**GOVERNMENT OF THE DISTRICT OF COLUMBIA
DEPARTMENT OF TRANSPORTATION**

MEMORANDUM

SUBJECT: **BZA Case No. 19599** – Georgetown Day School

Figure 2 Pedestrian and Bicycle Circulation

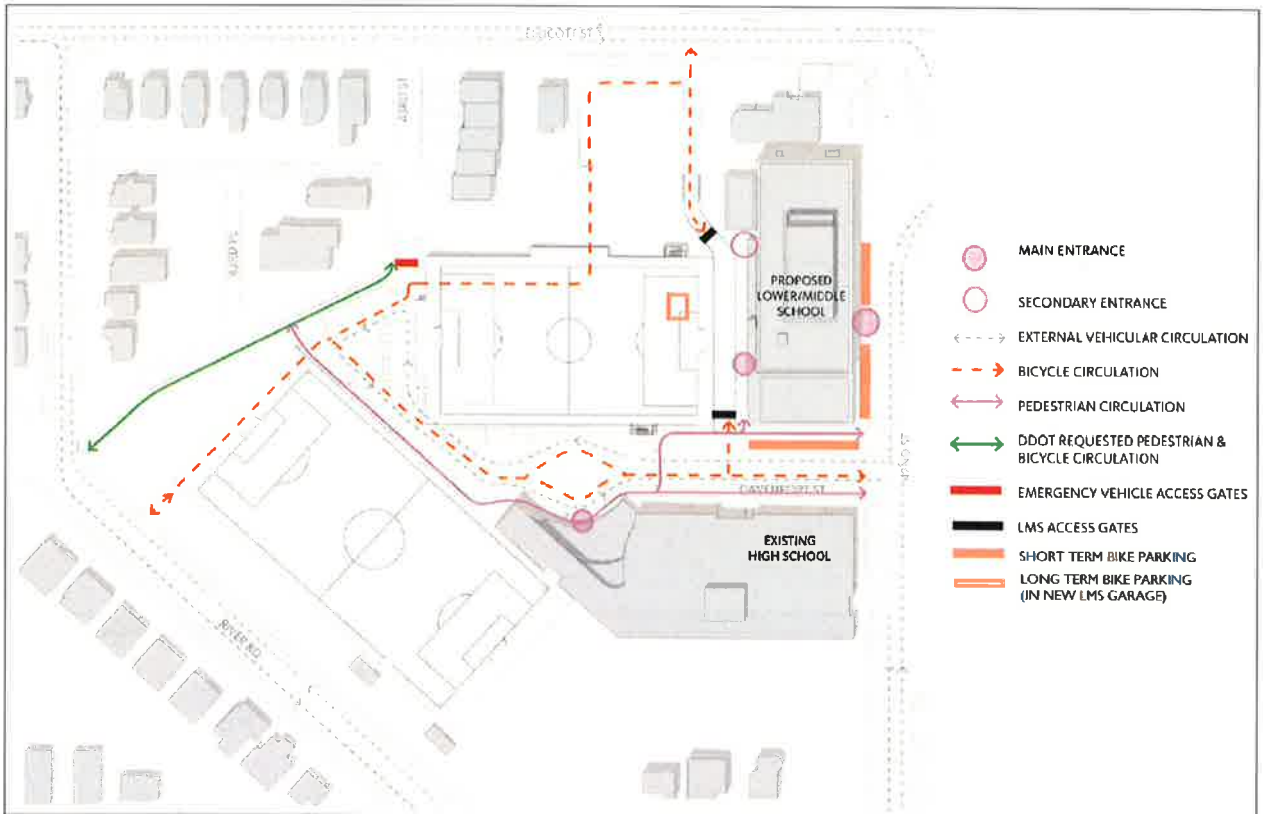
In addition to assessing the routes to the school, DDOT asked the Applicant to assess the ability for pedestrians to walk through the school campus to facilitate pedestrian access. The proposed site design includes several opportunities to promote walking. The Applicant worked with DDOT to install a sidewalk connection from the 43rd Place/River Road into the campus that provides north-south connectivity through the site. A sidewalk on the south side of the private east-west road through the site provides a connection to 42nd Street via Davenport Street. Of note, the site plan does not appear to provide an ADA accessible pedestrian connection between these two sidewalks, which DDOT expects the Applicant to address. Furthermore, no sidewalk connection exists on the north side of the private east-west road, which could be a barrier to pedestrian connectivity through the site as pedestrians would need to cross the road or walk through the parking lot. DDOT recommends that a sidewalk connection be explored on the north side of the private east-west road.

In addition to the 43rd Place/River Road pedestrian connection, the Applicant also agrees to re-open an existing closed pedestrian entrance at 43rd Street. To address neighborhood concerns with undesired vehicle drop-offs on 43rd Street south of Ellicott Street, the Applicant proposes to open the 43rd Street pedestrian entrance during school hours as a pilot program with conditions and triggers that would lead to the closure of the gate. While DDOT's preference is that the gate remain open in perpetuity in order to ensure additional pedestrian and bicycle connectivity, DDOT agrees in concept to opening the pedestrian entrance subject to ongoing monitoring to ensure appropriate use of the gate that does not induce vehicular pick-up/drop-off activities near the gate. However, the specific proposal for evaluating the pedestrian gate requires adjustments, which are discussed in the Mitigations section. As discussed above and in the Mitigations section, to complete the pedestrian connection to Ellicott Street, the Applicant should construct approximately 100 feet of sidewalk on the west side of 43rd Street between the alley and Ellicott Street where there is currently a gap in the sidewalk network.

The school's pedestrian circulation is shown in *Figure 2*.
